Exhibit A:
Response to Comments Submitted by RW Harden and Associates (RHW&A)
Prepared by: GMA 12 Consultants

INTERA, Inc., D. B. Stephens & Associates, and Ground Water Consultants, LLC. 2020. GMA 12 Update to the Groundwater Availability Model for the Central Portion of the Sparta, Queen City, and Carrizo-Wilcox Aquifers: Update to Improve the Representation of the Transmissivity Properties of the Simsboro Aquifer in the Vicinity of the Vista Ridge Well Field, Prepared for the Groundwater Management Area 12. October 2020

Cooper-Jacob Straight-Line Analysis for Determining Transmissivity Values from the 36-hour Pumping Test Data from PW-11 and PW-16

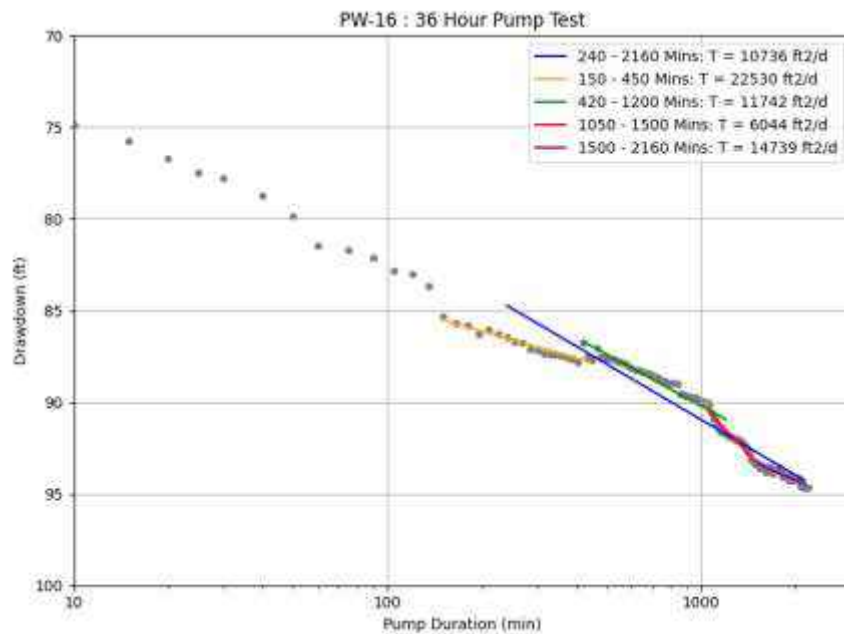
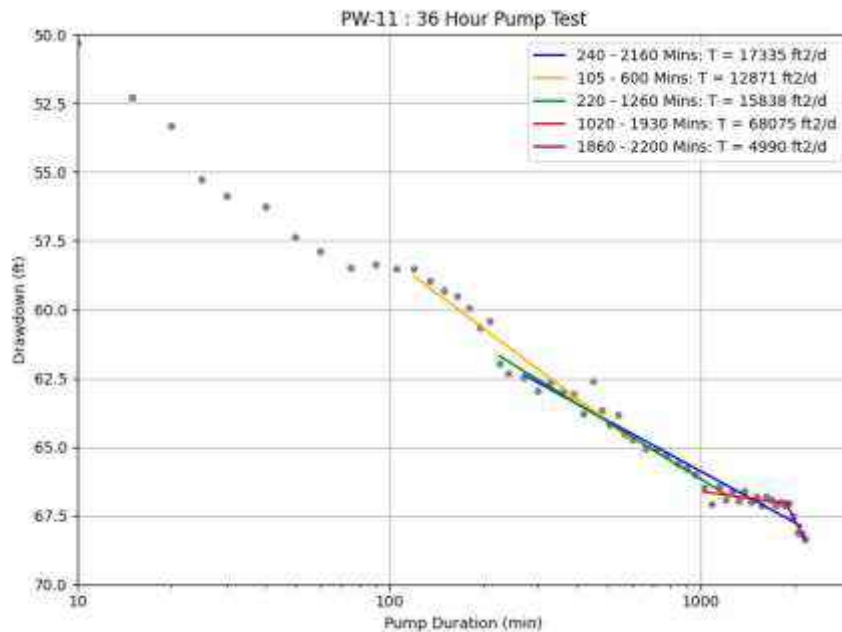
4. In order to illustrate that the spatial variability in the Simsboro transmissivity field is underestimated by using only the nine transmissivity values calculated from the nine aquifer

tests, INTERA has generated Attachment B. Attachment B shows results from applying the CJSI method over time periods of greater than 5 hours to the pumping tests for PW-11 and PW-16, using the same method used to analyze the 36-hour pumping tests in the GAM report. The analysis in Appendix B shows:

- For PW-11, the drawdown data was divided into four periods of between 5 and 19 hours for which CJSI transmissivity values were calculated. These four transmissivity values are: 12,871 ft²/day, 15,838 ft²/day, 28,075 ft²/day, and 4,900 ft²/day.
- For PW-16, the drawdown data was divided into four periods of between 5 and 13 hours for which CJSI transmissivity values were calculated. These four transmissivity values are: 22,500 ft²/day, 11,742 ft²/day, 6,044, and 4,900 ft²/day.

By parsing the aquifer test data into time periods of 5 hours and greater, we are able to find evidence of smaller scale variability in the transmissivity field than is possible by looking only at the transmissivity values calculated over 36-hour periods. The analysis of calculating transmissivity values over time scales less than 36 hours produces a range of transmissivity values for both wells that range from less than 60% to more than 50% of their reported values in Table 1.

Figure 3 Simsboro Transmissivity Field in the GAM (Young and others, 2018)

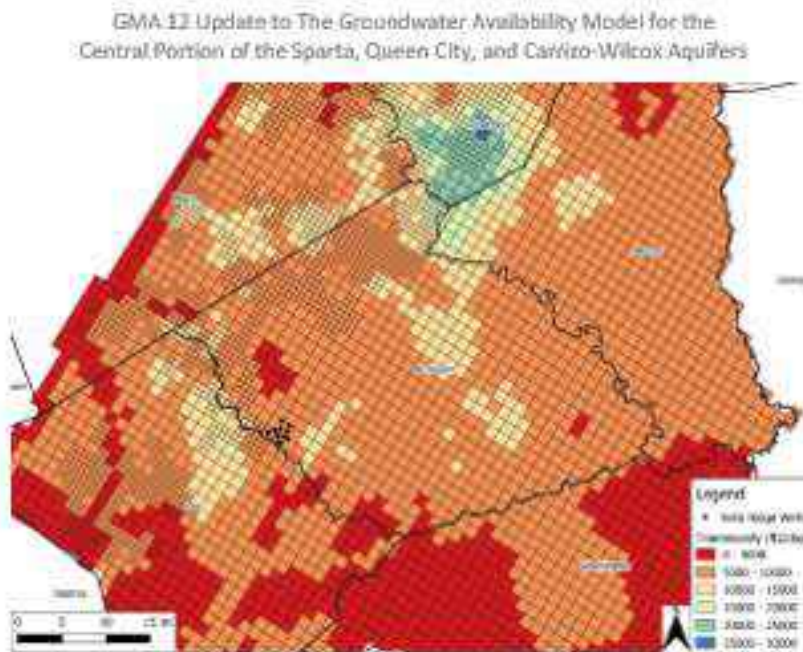
Comment #2. Simsboro (Layer 9) Transmissivity Artifact. There appears to be a modeling/interpolation artifact in the modified Simsboro transmissivity field encompassing the Vista Ridge well field area. As shown in Figure 1, there is a distinct, box-shaped transition zone between the modified and unmodified cells that is not consistent with the recorded, regional distribution of hydraulic parameters in the Simsboro. For example, the transmissivity of modified model cells near the eastern transition zone ranges from approximately 5,700 to 19,600 ft²/day, while nearby unmodified model cells are much less transmissive, with maximum assigned values ranging up to about 9,400 ft²/day. The apparent artifact correlates to the orientation of the pilot point array applied to PEST as shown in Figure 2 of INTERA's October 2020 report. This box-shaped transition suggests that the parameter estimation results and the methods by which those values were integrated into the original transmissivity field should be re-analyzed and possibly corrected.

transmissivity much larger than 25% occur across a mile distance in many regions of the unmodified transmissivity field such as in Robertson County (Attachment A, Figure 3) and among transmissivities that were calculated among the Vista Ridge Simsboro Aquifer screened wells. A third important observation is that, it appears that a similar box could have been drawn around the high transmissivity values in Robertson County in the unmodified GAM (see Attachment C, Figure 3) to encompass elevated transmissivity values associated with the City of Bryan/College Station well field.
